7-ELEVEN STORE #42975 SITE #1057022
MAJOR SITE DEVELOPMENT PLAN

MAJOR SITE DEVELOPMENT PLAN
7-ELEVEN - STORE #42975
SITE #1057022
BRADLEY ROAD AND LEGACY DRIVE
COVER SHEET

MAJOR SITE DEVELOPMENT PLAN
7-ELEVEN - STORE #42975
SITE #1057022
BRADLEY ROAD AND LEGACY DRIVE
UTILITY PLAN

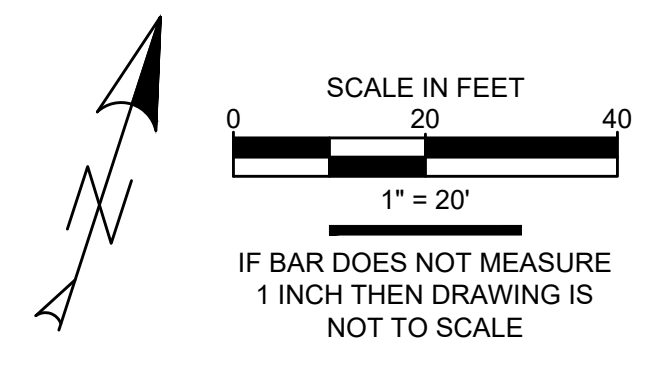
Add note "CSU Field Engineer to determine final gas meter and service line locations. Contact Field Engineering at 719-668-4985 (Gas) with any questions."

CSU GIS shows the gas main extending to the west edge of the traffic circle in Legacy Hill Drive. Please confirm gas main extension and proposed service line connection location

Gas meter location on plan view and building elevations must be shown and labeled.

Add note " Gas meters must be a minimum of 3-feet from doors, operable windows, or any vents or openings in walls."
